FILE BRST-0729(13) & (12) Candler County
P.I. Nos. 542401 & 542402

SUBJECT PROJECT CONCEPT REPORT

FILE **BRST-0729(13) & (12)**
SR 129 over Canoochee River and Overflow bridge replacements
P.I. No. 542401 and 542402

Office of Consultant Design
Project Concept Report

TYPICAL SECTION

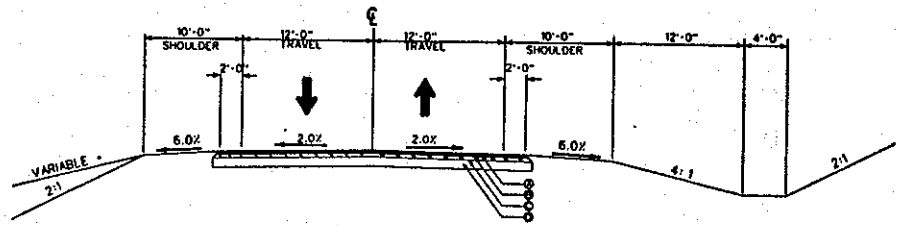
plan of action. Mr. Sheffield's last comment was that the alternative of a detour bridge was not to be considered due to the expense of the detour bridge and that it extends construction time by six months or more. Donnie Boyd made the suggestion that shifting the alignment to the west side would clear up all access issues. This shift would result in extending the job in order to flatten out the horizontal curve at the north end of the project. Also, the implementation of the west alignment would reduce the utility cost considerably. (No power pole relocations necessary.) Tony Collins made an observation about the typical section. The slope control table should be referenced properly on the typicals. The typical section was approved by all in attendance.

GDOT – Jesup Road Design: Dennis Odom made the comment to ensure that there is adequate tangent length in the area of the road where there is superelevation.
